# Conceptual Review Agenda

Schedule for 09/15/14 to 09/15/14

# 5305 Ziegler Rd Multi-family

CONCEPTUAL REVIEW:  
APPLICATION

**ODP - CONCEPTUAL UTILITY PLAN**

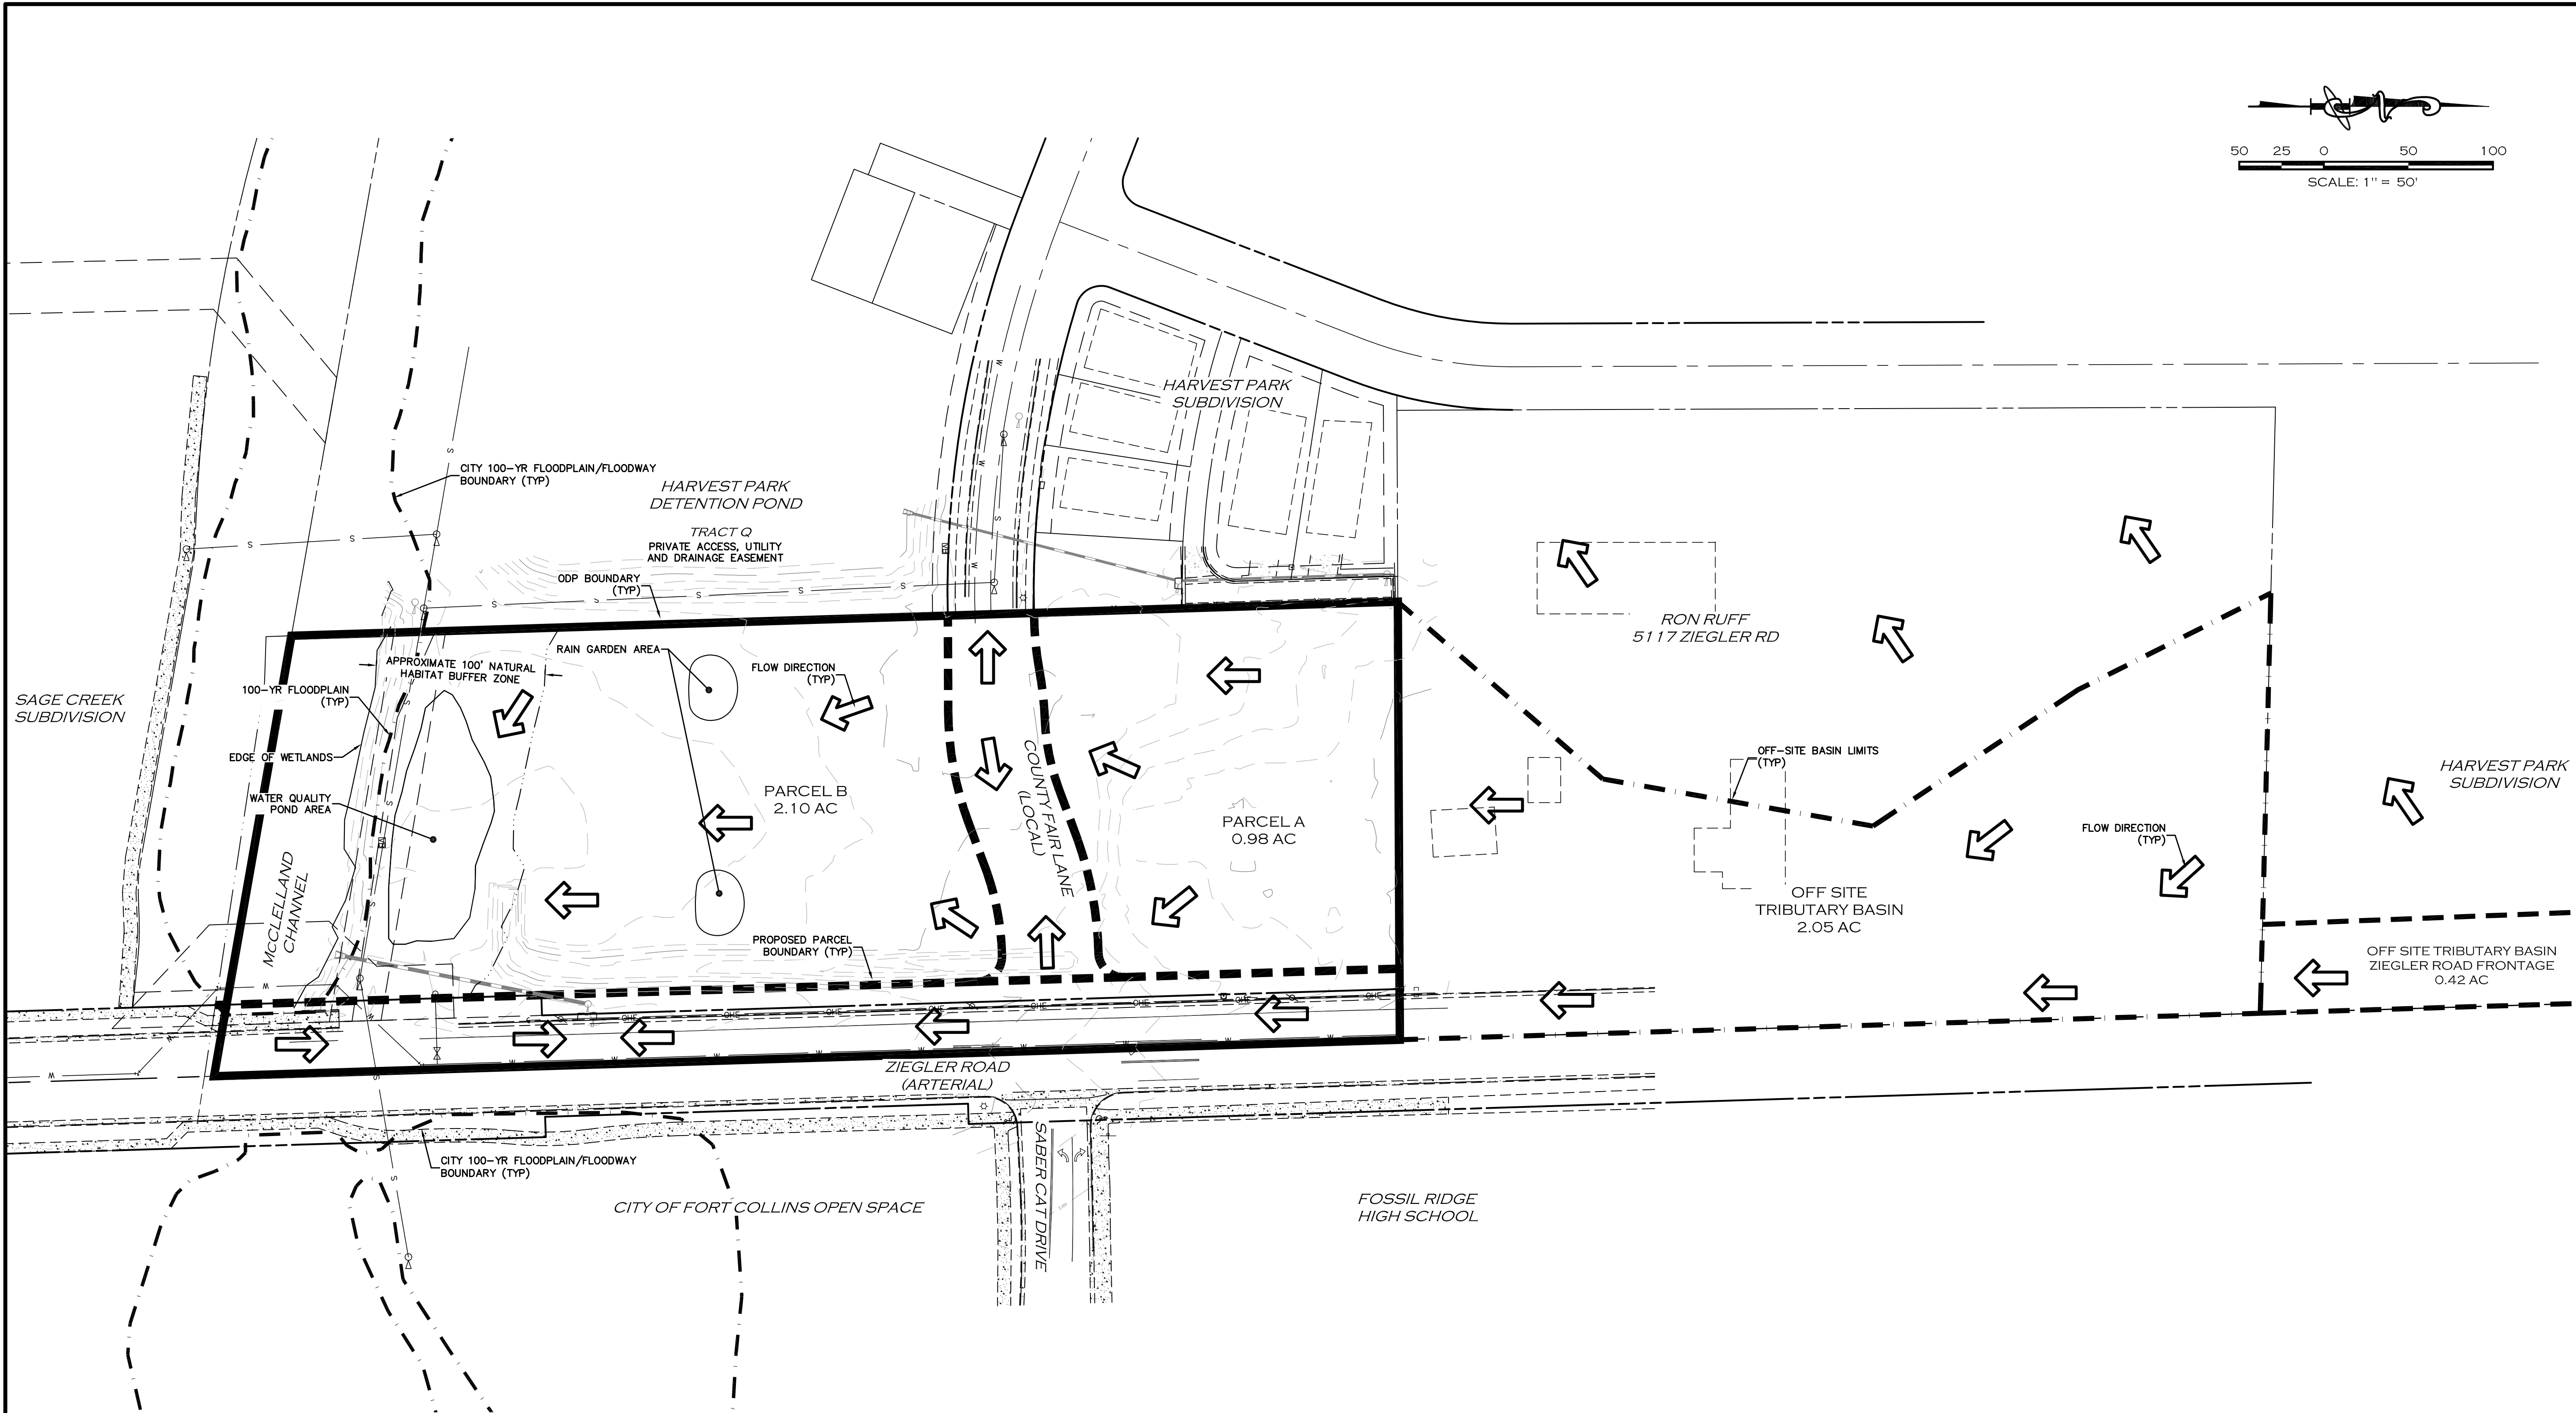
12. (Sheet 102) Harvest Park was built with a subdrain system that looked to address high groundwater for both the public street system and basement foundations. The soils report required with the project should address whether similar mitigation measures might be needed with the extension of County Fair Lane.

SITE PLAN

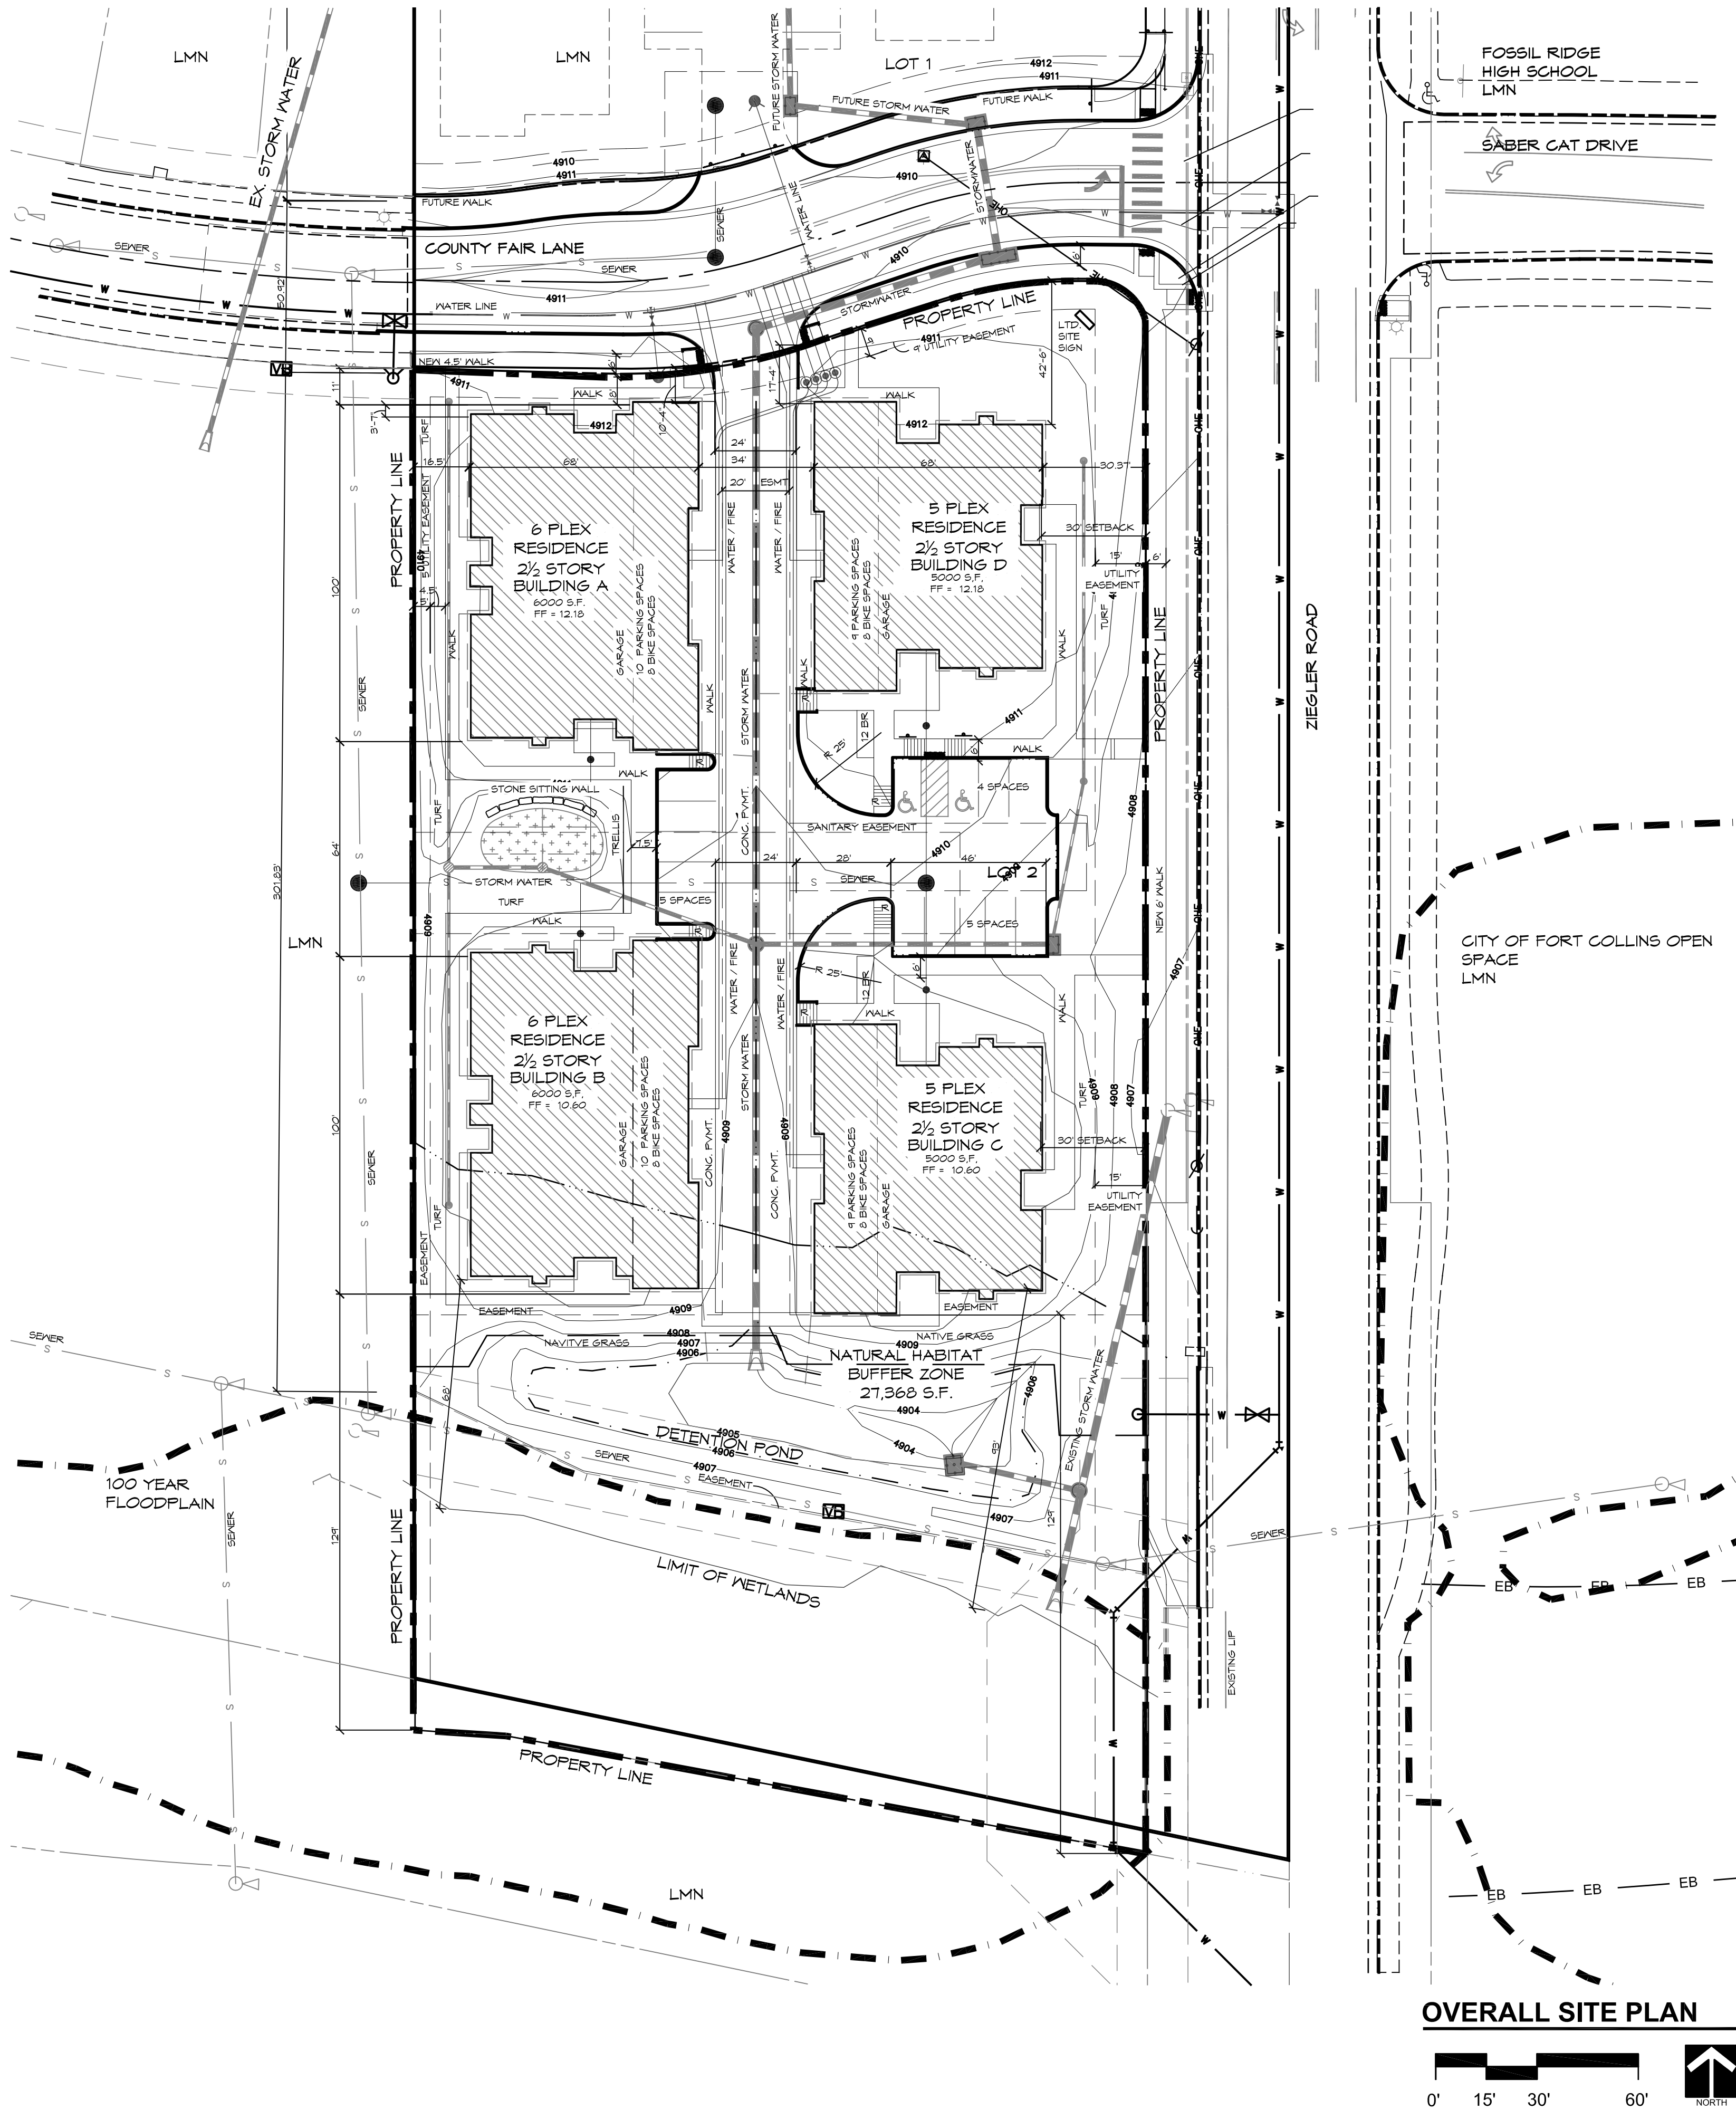
1. Parking/Parking Lot requirement per LUC 3.2.2(H) shall be adhered to.
2. Please remove the entry sign shown on the site plan. Any signage including proposed location shall be approved through separate sign permitting process per LUC 3.8.7.

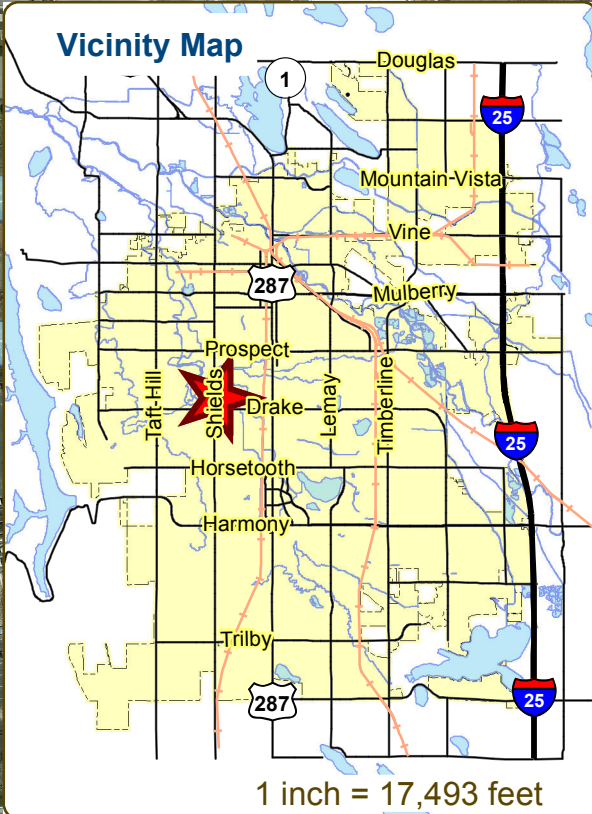
1. Context Is Crucial. A first task in any further planning for this property is to show proposed development in context, with a plan showing relationships to adjacent properties, a direct and integral street connection to the Neighborhood Center, Boxelder Road connection to Prospect, floodplains/floodways, natural area buffers, future employment uses, the concept of a park to the north, and so on.
2. Employment Uses. The proposed plan appears to indicate a reduction in land for employment uses, which are already constrained by Boxelder Creek. In showing the plan in context, viable employment sites should be considered as part of a mixed use area. It appears that detention, Boxelder Creek floodplain and buffers, and street connections are constraints that appear to be disproportionately allocated in employment portions of the ODP.

3. 'Boxelder Road'. Access from the 'Boxelder Road' access point on Prospect Road appears to be very important for a number of reasons as a second point of access to the neighborhood other than the Interstate Frontage Road; as part of improving direct access to the Neighborhood Center, and generally adding an interconnection to the street network.

4. Neighborhood Center Access. Multimodal access from the housing to the Neighborhood Center should consist of a much more direct street connection that is shown on the concept plan. This is integral with the comment about Boxelder Road.

5. 'Secondary Access'. As shown, this appears to consist of a rear, indirect driveway rather than a direct street connection. This should be a more direct and formative component of the plan.

6. Locust Street. A connection may be required. This needs further consideration with Land Use Code Section 3.6.3(F) as a key consideration.
7. Housing Types. Four are required, the plan appears to show three.

CONCEPT PLAN

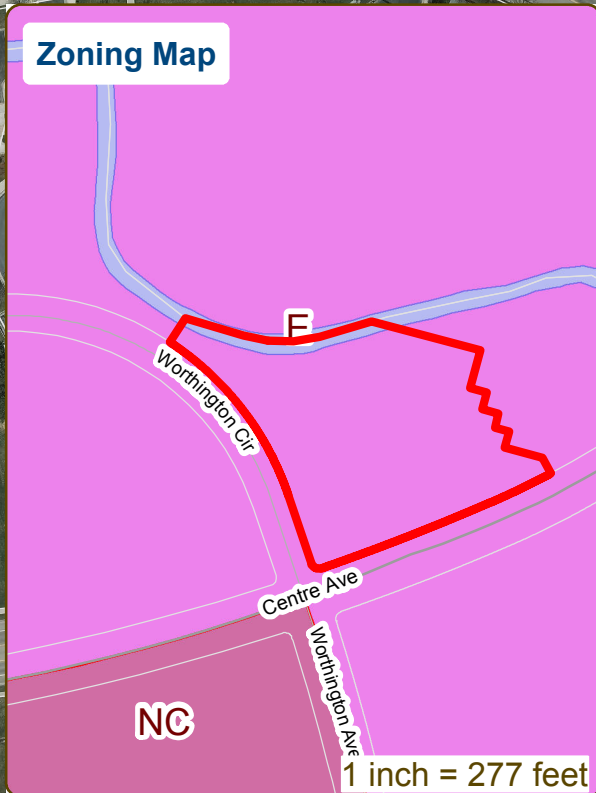
6. The architecture of the two new buildings will be required to complement the existing building.
7. Is there any common outdoor space proposed? If so, please indicate on the Site Plan.

8. The original Final Plan shows that Building Two Phase Two, which is now the proposed two-story six-plex, is connected to Centre Avenue with a walkway. The proposed building should be similarly connected.
